ECE/TRANS/WP.29/2007/64
12 July 2007

World Forum for Harmonization of Vehicle Regulations

Proposal for Supplement 29 to the 03 series of Amendments to Regulation No. 37

(Filament lamps for use in approved lamp units)

" CATEGORIES H6W AND HY6W Sheet H6W/1

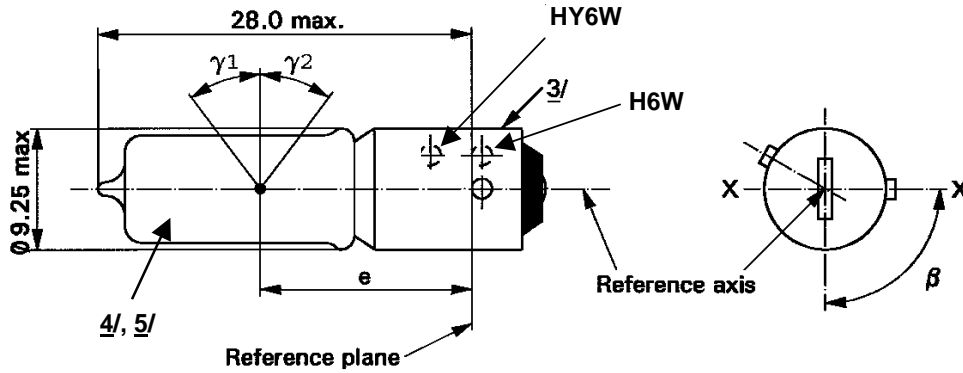
Sheets H6W/1, amend to read:

Dimensions in mm		Filament lamps of normal production			Standard filament lamp
		min.	nom.	max.	
E		14.25	15.0	15.75	15.0 ± 0.25
Lateral deviation	<u>1/</u>			0.75	0.4 max
α		82.5°	90°	97.5°	90° ± 5°
γ1, γ2	<u>2/</u>	30°			30° min.
Cap:	H6W: BAX9s HY6W: BAZ9s	in accordance with IEC Publication 60061 (sheet 7004-8-1) in accordance with IEC Publication 60061 (sheet 7004-150-1)			
ELECTRICAL AND PHOTOMETRIC CHARACTERISTICS					
Rated values	Volts	12			12
	Watts	6			6
Test voltage	Volts	13.5			13.5
Objective values	Watts	7.35 max.			7.35 max.
	Luminous flux	H6W	125 ± 12 %		
		HY6W	75 ± 17 %		
Reference luminous flux at approximately 13.5 V					White: 125 lm Amber: 75 lm

Sheet H21W/1

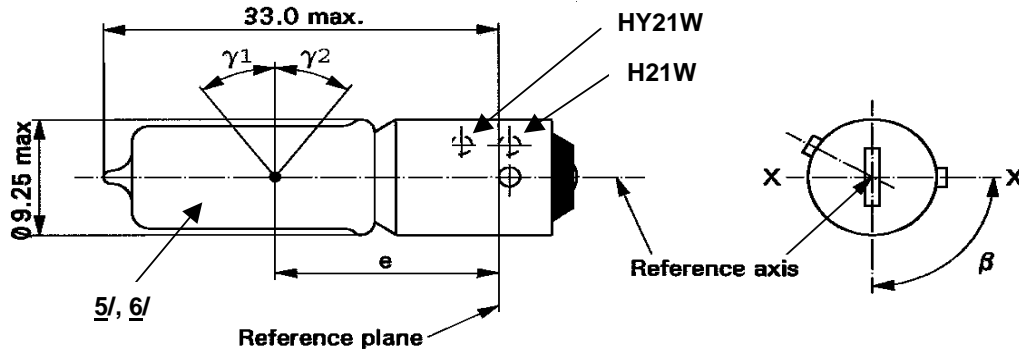
Sheet H21W/1, amend to read:

Dimensions in mm		Filament lamps of normal production			Standard filament lamp
		min.	nom.	max.	
e			20.0 <u>1/</u>		20.0 ± 0.25
f	12 V			3.8	3.8 + 0/ - 1
	24 V			4.5	
Lateral deviation <u>2/</u>				<u>1/</u>	0.0 ± 0.15 <u>3/</u>
β		82.5°	90°	97.5°	90° ± 5°
γ1, γ2 <u>4/</u>		45°			45° min.
Cap:		H21W: BAY9s	in accordance with IEC Publication 60061 (sheet 7004-9-1)		
		HY21W: BAW9s	in accordance with IEC Publication 60061 (sheet 7004-149-1)		
ELECTRICAL AND PHOTOMETRIC CHARACTERISTICS					
Rated values	Volts		12	24	12
	Watts		21	21	21
Test voltage	Volts		13.5	28.0	13.5
Objective values	Watts		26.25 max.	29.4 max.	26.25 max.
	Luminous flux	H21W	600 ± 12 %	600 ± 15 %	
		HY21W	300 ± 17 %	300 ± 20 %	
Reference luminous flux at approximately				12 V	White: 415 lm
				13.2 V	White: 560 lm
				13.5 V	White: 600 lm

Sheet HS6/1

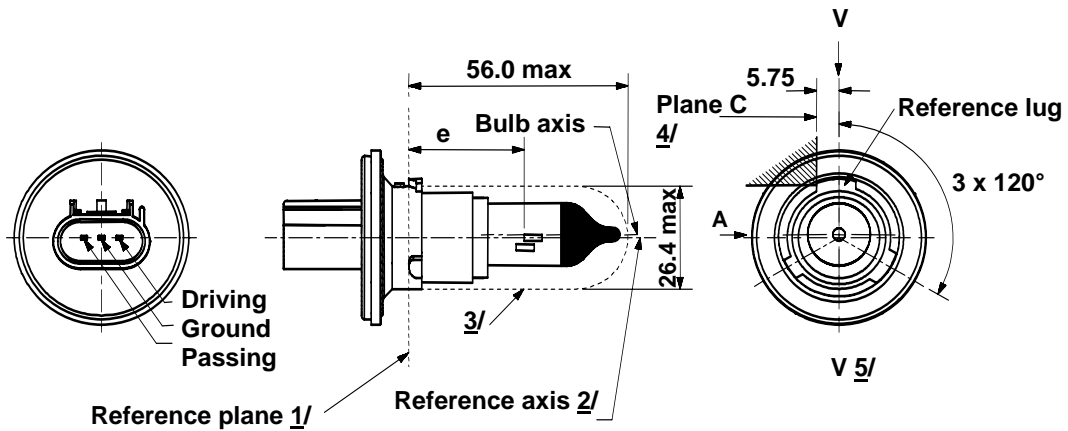
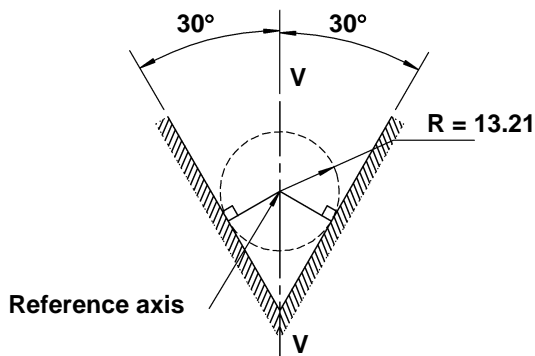
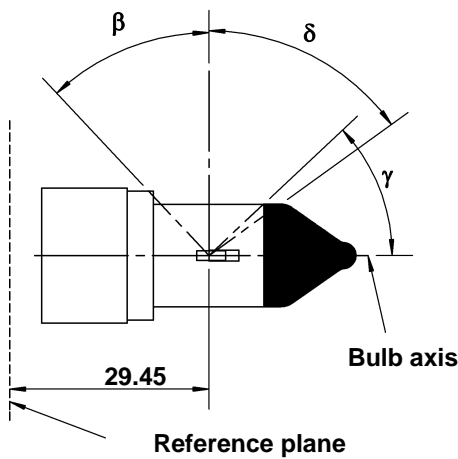
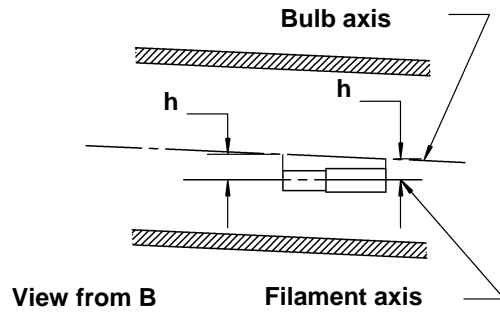
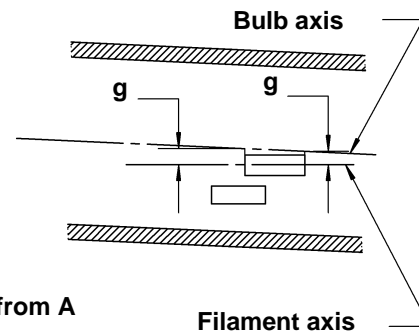
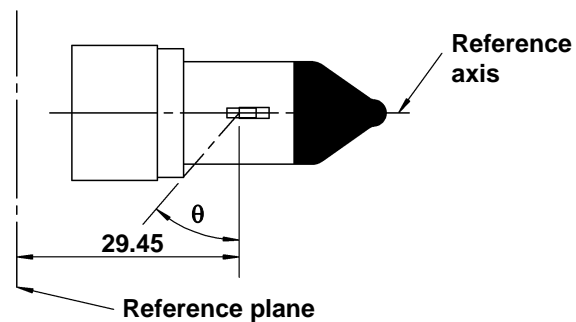
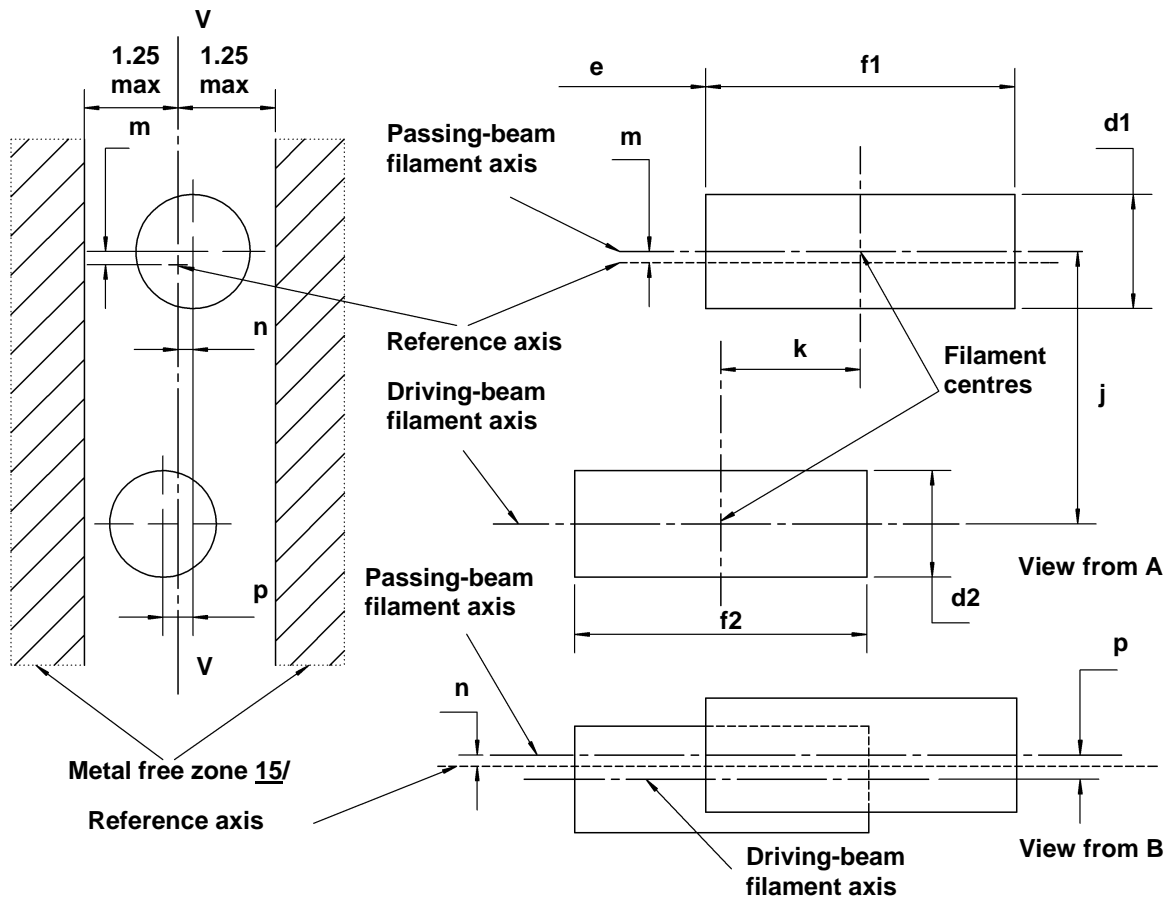
Insert new sheets HS6/1 to 4, between sheet HS5/4 and sheet P13W/1, to read:

Dimensions in mm			Tolerance			
			Filaments lamps of normal production		Standard filament lamp	
d1	<u>13/ 17/</u>	1.4 max.	-		-	
d2	<u>13/ 17/</u>	1.4 max.	-		-	
e	<u>16/</u>	29.45	± 0.20		± 0.10	
f1	<u>16/</u>	4.4	± 0.50		± 0.25	
f2	<u>16/</u>	4.4	± 0.50		± 0.25	
g	<u>8/ 17/</u>	0.5 d1	± 0.50		± 0.30	
h	<u>8/</u>	0	± 0.40		± 0.20	
j	<u>10/</u>	2.5	± 0.30		± 0.20	
k	<u>10/</u>	2.0	± 0.20		± 0.10	
m	<u>11/</u>	0	± 0.24		± 0.20	
n	<u>11/</u>	0	± 0.24		± 0.20	
p	<u>10/</u>	0	± 0.30		± 0.20	
β		42° min.	-		-	
δ		52° min.	-		-	
γ		43°	+0° / -5°		+0° / -5°	
θ	<u>9/</u>	41°	± 4°		± 4°	
Cap: PX26.4t in accordance with IEC Publication 60061 (sheet 7004-[xxx-x])						
ELECTRICAL AND PHOTOMETRIC CHARACTERISTICS <u>18/</u>						
Rated values	Volts	12		12		
	Watts	40	35	40	35	
Test voltage	Volts	13.2		13.2		
Objective values	Watts	45 max.	40 max.	45 max.	40 max.	
	Luminous flux	900 ± 15 %	600 ± 15 %			
Reference luminous flux at approximately		12 V		630/420
